Development Permit Panel Electronic Meeting

1. **GENERAL COMPLIANCE – REQUEST BY CHRISTOS PLATIS (ONNI 7811 ALDERBRIDGE HOLDING CORP.) FOR A GENERAL COMPLIANCE RULING AT 7811 ALDERBRIDGE WAY**

(File Ref. No.: DP 18-841057) (REDMS No. 8420202)

2. **DEVELOPMENT VARIANCE PERMIT 23-018630**

INDOOR AMENITY EXPANSION

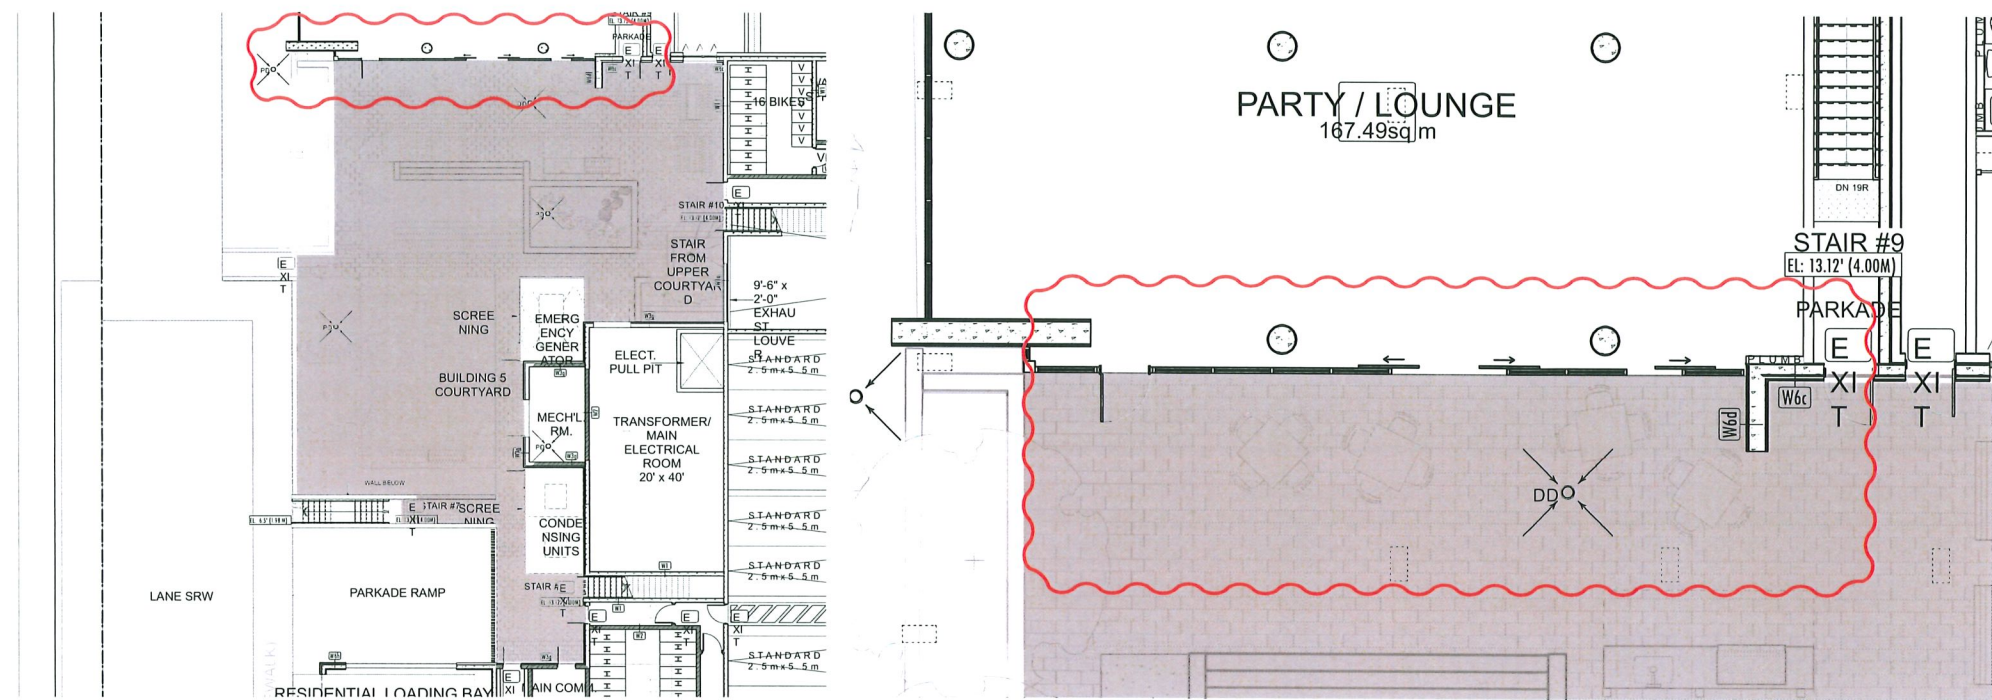
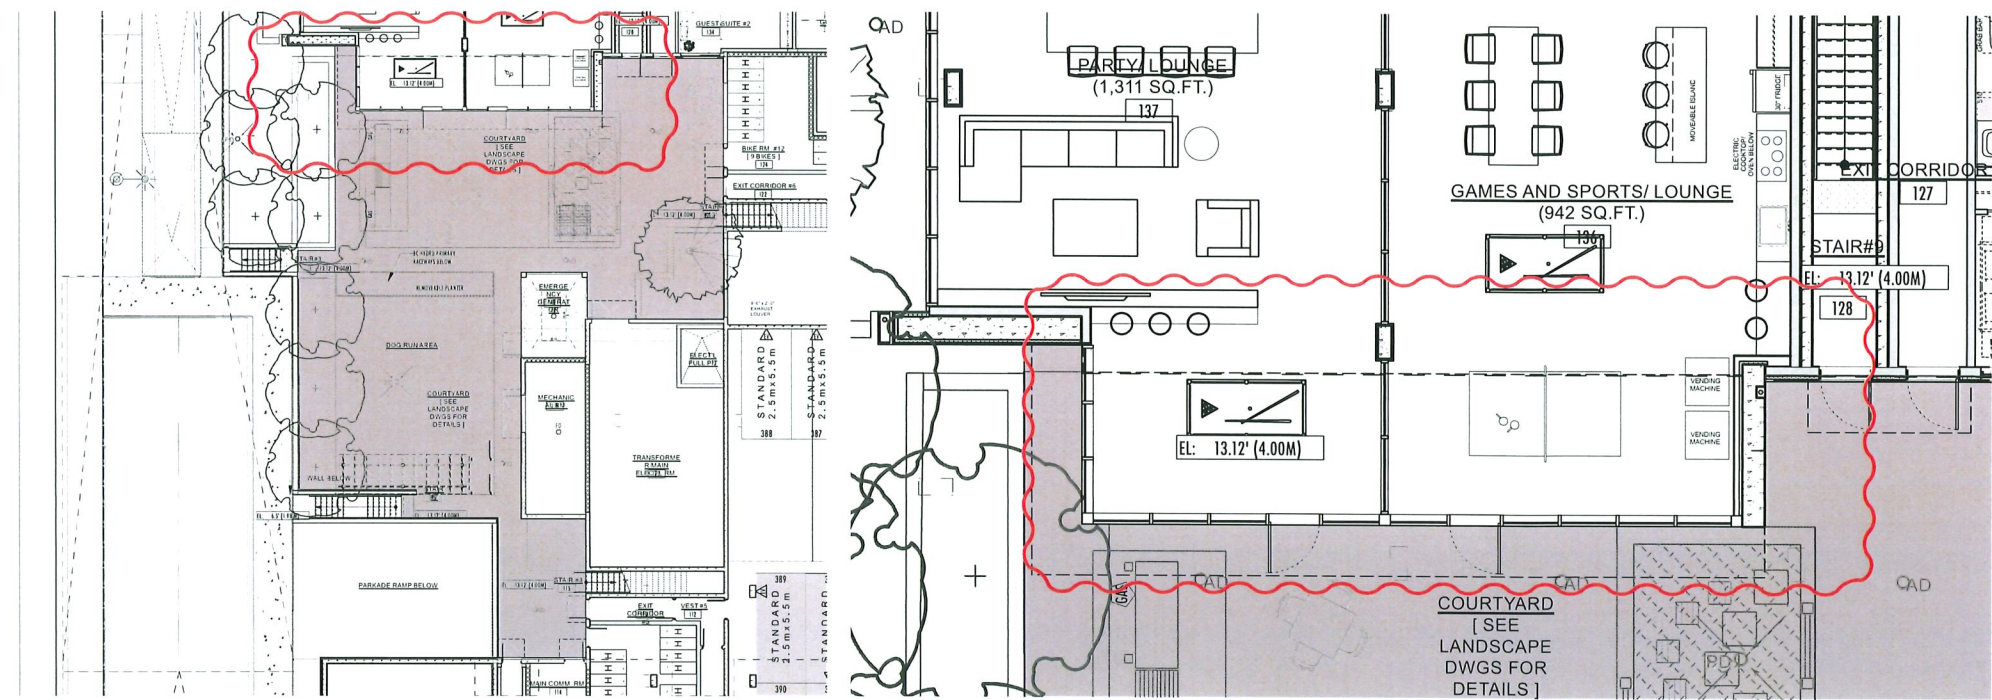
- The total number of units in Riva 5 and 6 has been increased from 368 units to 386 units. Accordingly, the Level 1 indoor amenity area, which is shared between Riva 5 and Riva 6, has been expanded and reconfigured. Based on the revised unit count, 772 m² (8,310 ft²) of indoor amenity space is required. The proposal provides approximately 791 m² (8,514 ft²), which exceeds the City's minimum indoor amenity space requirement.

REVISED PARKING GRID/LAYOUT - FROM 2 BAY TO 3 BAY STRUCTURAL GRID

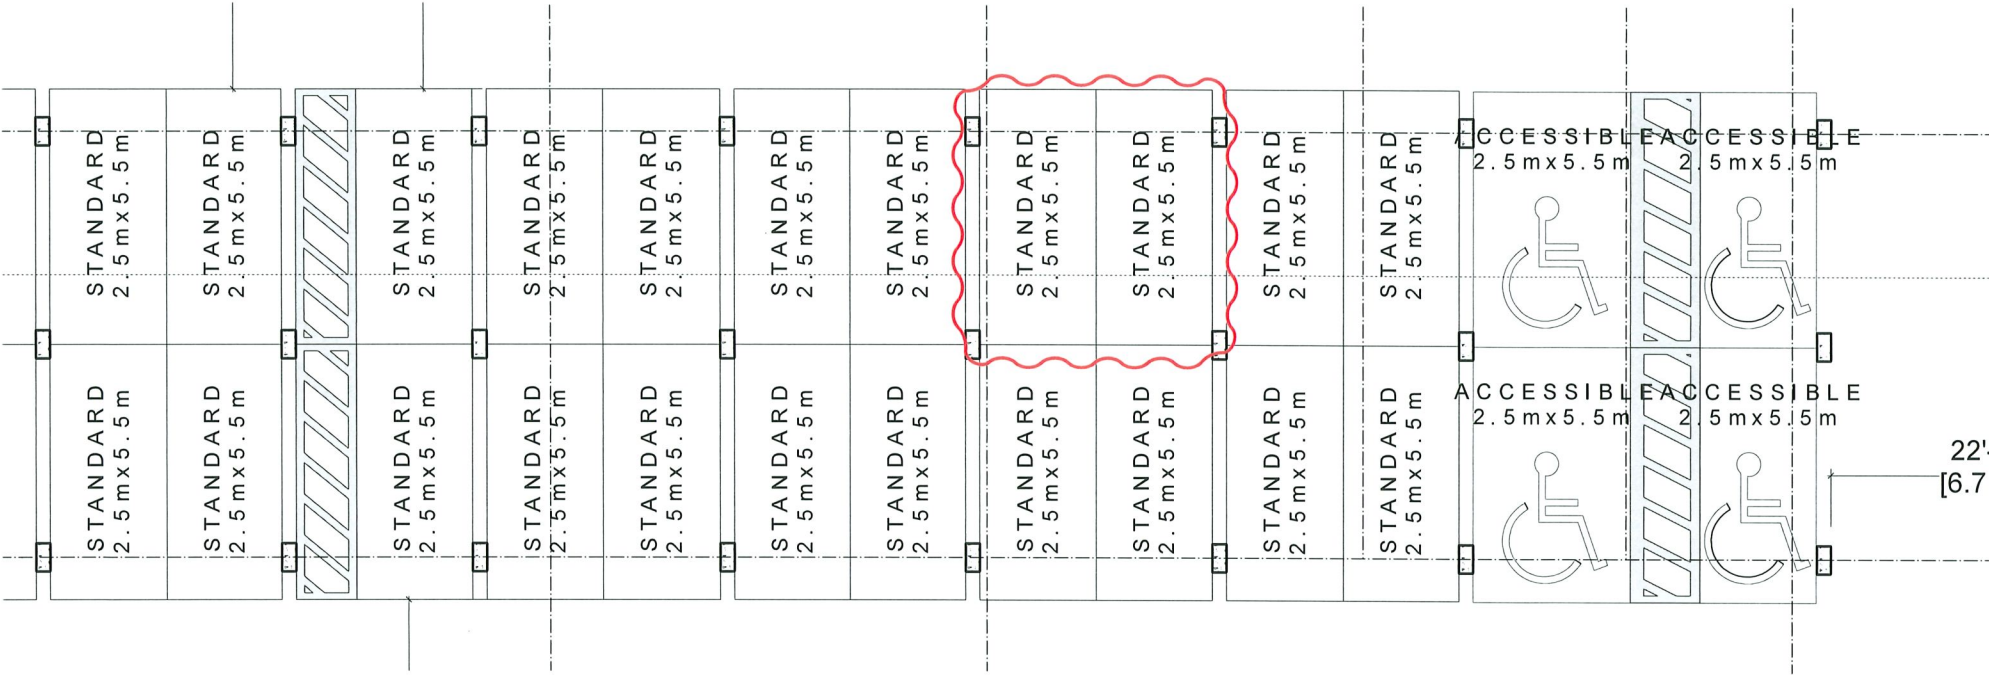
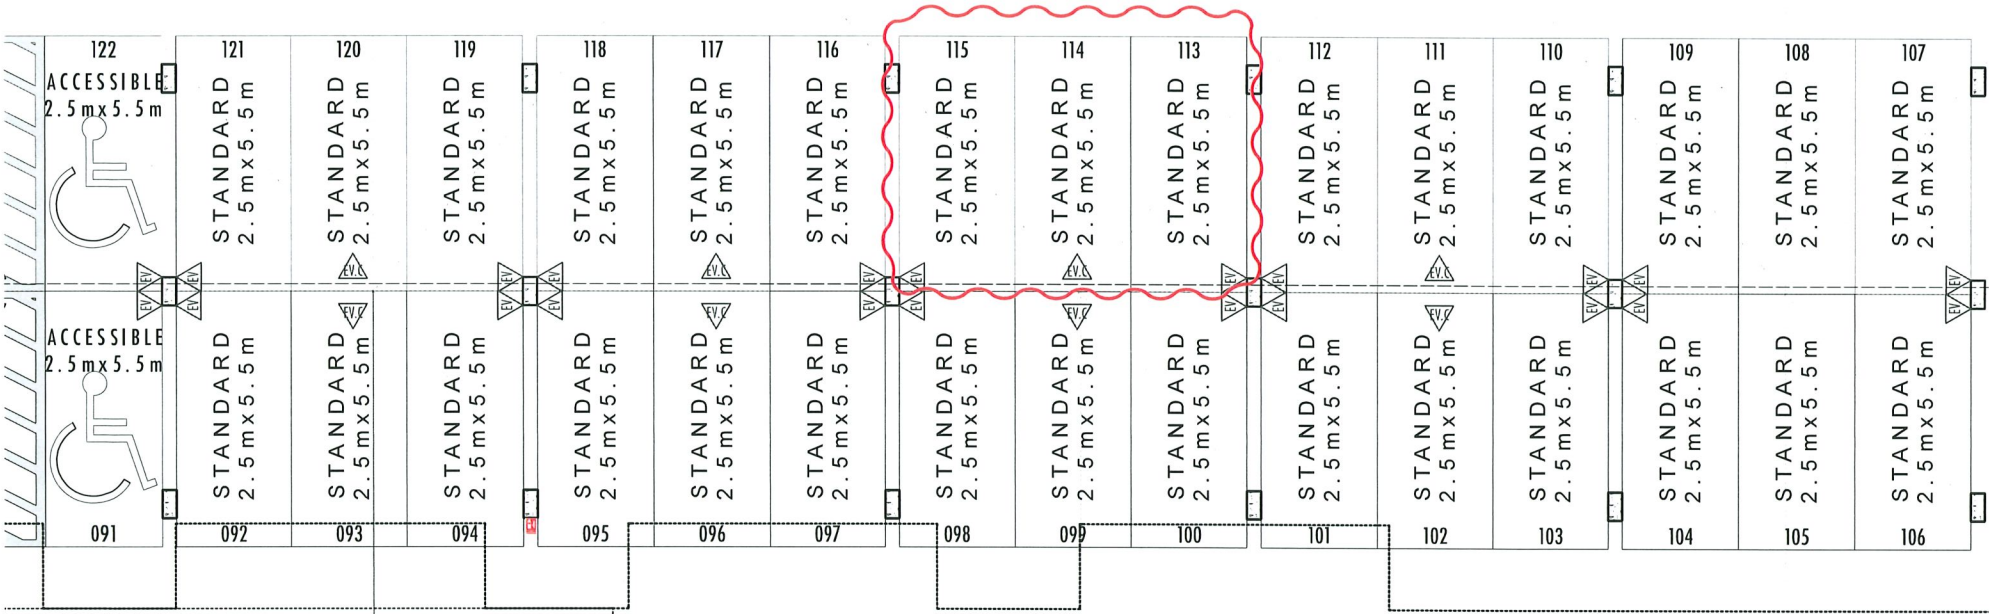
- Revision of the parkade structural grid and column spacing from a two-bay to three-bay configuration to improve circulation, space planning flexibility and structural coordination. No changes are proposed to the approved number of parking spaces.
- Increase in the number of Class 1 bicycle parking spaces from 462 to 483 spaces, and the Class 2 spaces from 76 to 78 as a result of the increase in the number of residential units. Proposed bicycle parking would comply with minimum Zoning Bylaw requirements.
- Redistribution of Class 2 bicycle parking on site, with additional bicycle parking relocated to the East-West Greenway frontage to improve visibility, accessibility and integration with the active transportation network. Accordingly, a modification of the existing Bike Facilities covenant is required as a condition of General Compliance to address changes to bike parking on-site.
